PRE APPLICATION 03 (2ND FEBRUARY 2023)

The third pre-app meeting in February 2023 was mainly focused on providing technical details to answer the several queries raised during the first pre-app and presenting the option for the new entrance at unit 38a with subsequent changes to the layout. The following topics has been discussed during the meeting:

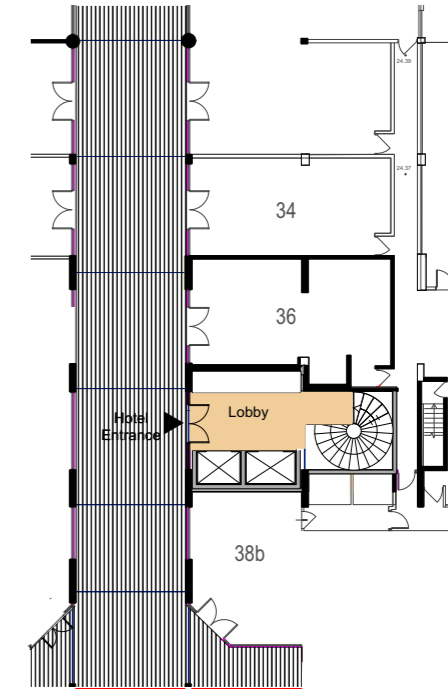
Comments : The officer stated that the circadian lighting looks positive and queried whether the energy intensity of the circadian lighting had been considered in the modelling'

- The team confirmed that Lux assessments had been undertaken in respect of the circadian lighting and that the scheme will be able to exceed the minimum Lux requirements. The team confirmed that the circadian lighting will produce very similar results to natural daylight. It is proposed to install multiple skylights within the lightwells to ensure the total spread of light at the site does not reduce below 100 Lux

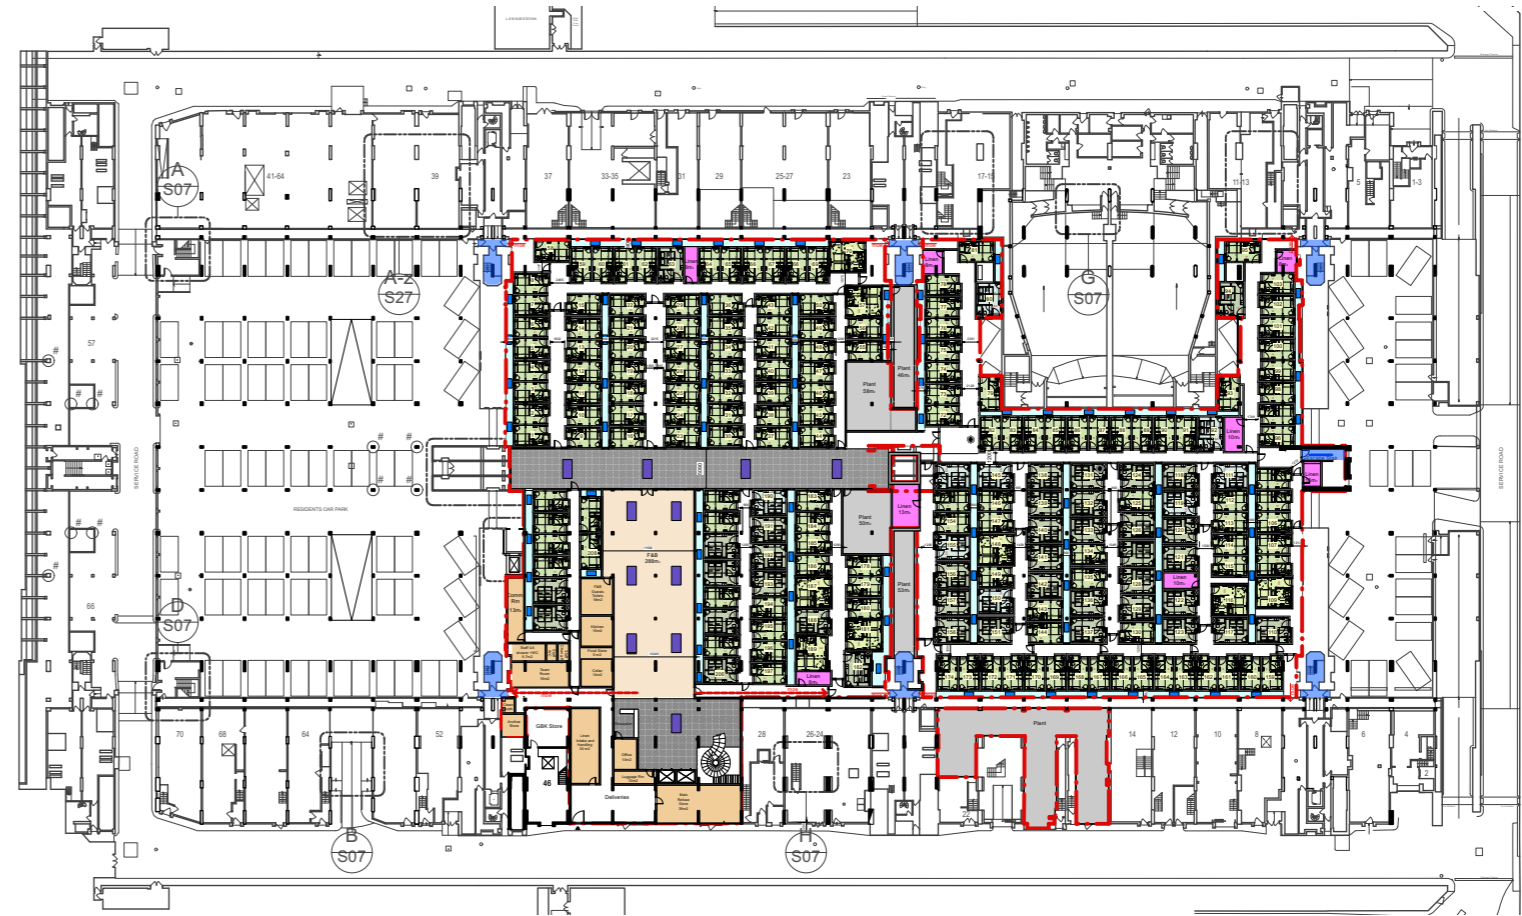
Comments : Officers showed interest in the proposed slab lowering and asked the applicant to develop the option and provide more details on methodology and feasibility

- HTS presented the two structural interventions considered in relation to the existing concrete slab. The first option involved the demolition of the existing concrete slab and its replacement with a new, lower slab. The second option was the retention and lowering of the existing concrete slab. This would involve propping the slab from below prior to dividing it into separate panels and lowering them each in turn.
- HTS confirmed that there would be less noise associated with the second option as the slab would not need to be broken up and transported away from the site

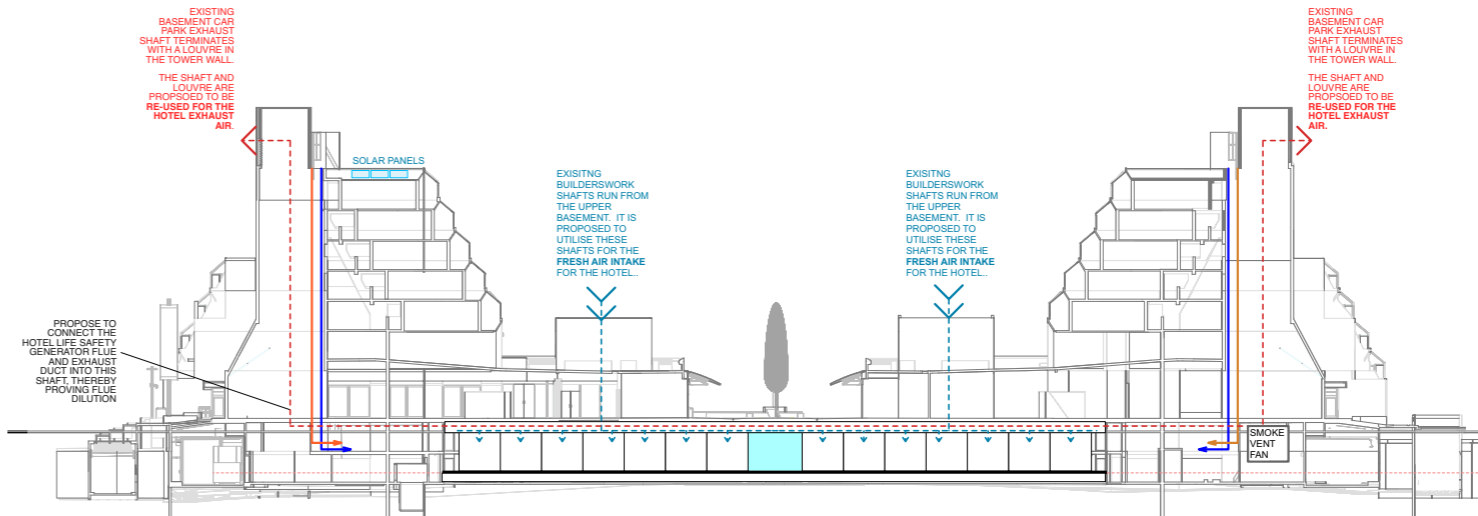
Comments : The officer stated that rainwater and greywater harvesting are typically expected for hotels as they have a high-water use and that a feasibility assessment would be required with alternatives explored.

- HTS confirmed that the current drainage strategy comprises pumped drainage at the existing B2 level with everything else discharging at high level basement level under gravity (including rainwater)

MARCHMONT ST AERIAL VIEW

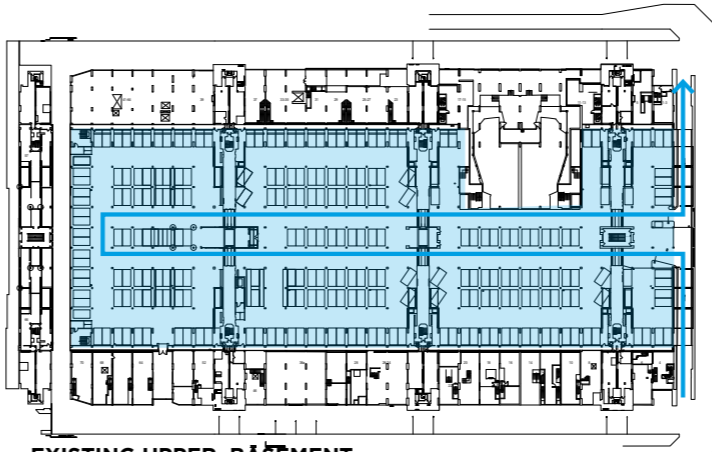
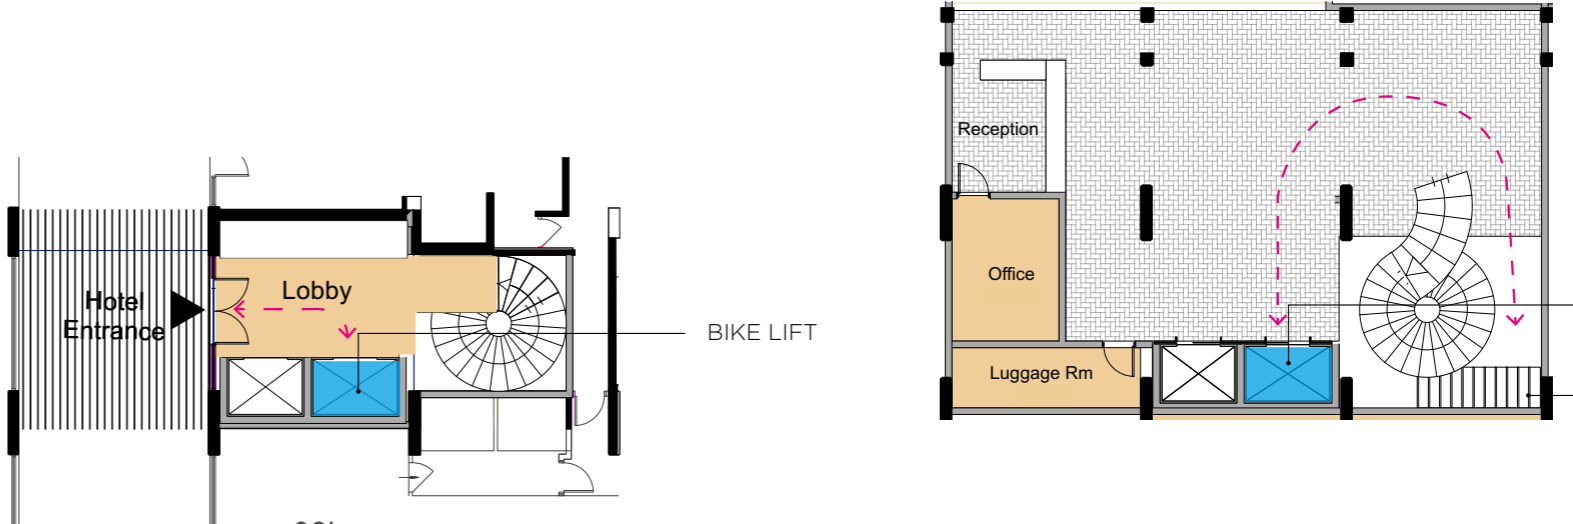
Comments : The officer suggested that it would be useful to agree the required townscape views with the Council in which to test the additional plant equipment and potential acoustic screening.

- PSH stated that the scheme is seeking to utilise the existing ventilation shafts which distribute to ventilation plant rooms in the basement
- Condensers for heating, cooling and hot water generation are proposed at roof level, in addition to PV panels
- The team were looking to locate the condensers on the roof next to existing structures so as to minimise additional massing

PROPOSED PARKING & CIRCULATION

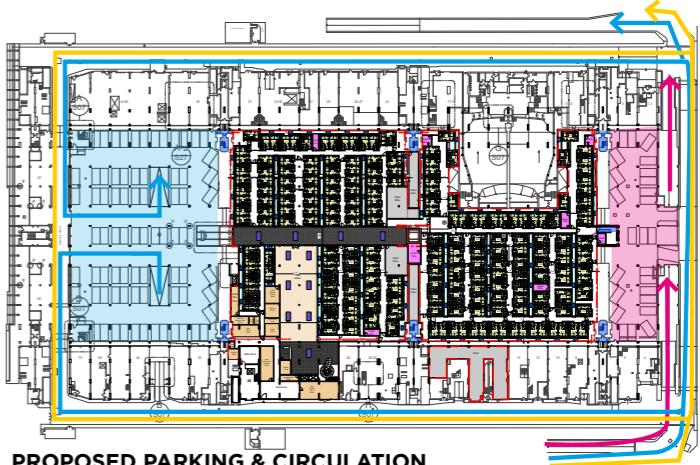
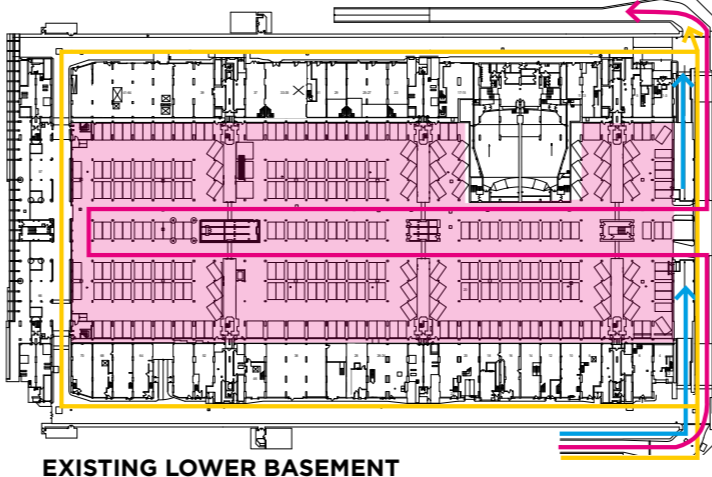
Comments : officers were generally accepting of approach on transport. Concerns were raised regarding the location of the cycle racks under the spiral stair.

- The team was seeking to accommodate cycle parking at the entrance of the plaza level beneath the spiral staircase
- Reduction in 157 car parking spaces from the NCP car park. The Waitrose parking would be provided within the northern area of the car park and creation of two ramps would be necessary to allow circulation on the two levels
- Approx. 45 spaces for residents will be retained at the southern part of the car park with no alteration of the existing ramps
- The project would utilise the existing servicing route for all deliveries to the hotel
- RGP confirmed that there are a number of disabled bays on the street nearby that could be used for this purpose
